CERTIFICATE OF APPROPRIATENESS

This letter provides you with confirmation that the proposed changes to your designated Fort Collins landmark property, the C.M. Smith House at 622 Remington St., have been approved by the City's Historic Preservation Division because the proposed work meets the criteria and standards in Chapter 14, [Article IV](#) of the Fort Collins Municipal Code.

Design Review Application Historic Preservation Division

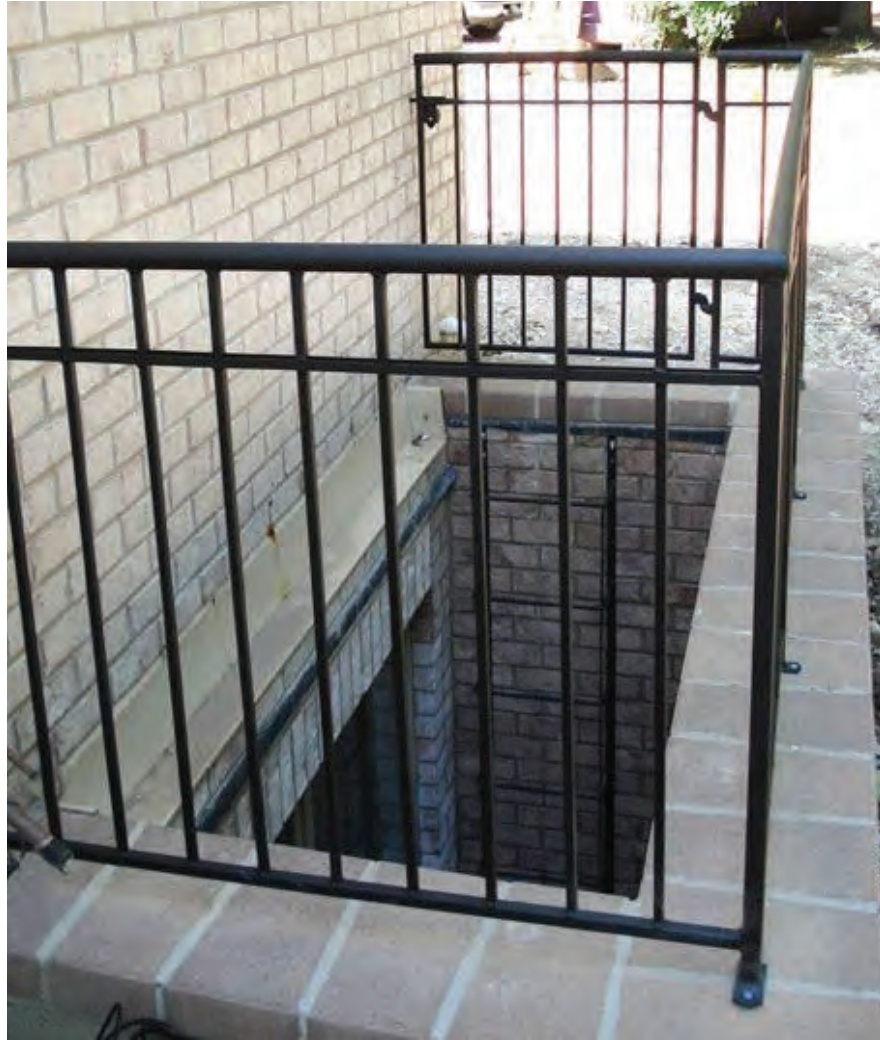
p.s. A quick update about the **egress window**: Our contractor wasn't able to find an in-swing egress casement window in fiberglass, wood, or aluminum, so we would need to switch to an *out-swing* casement window to be able to accommodate an alternative material.

An out-swing casement window is incompatible with having a safety grate over the window well, since part of the window is above grade and would bang into the grate. Code would thus require us to install a safety rail instead. I'm including a sample image below of what such a railing would look like.

This would have a much more dramatic impact on the external appearance of our home. We're worried too that it simply doesn't provide the same level of safety that a grate over the window well would for our kids. A railing practically invites children to climb all over it.
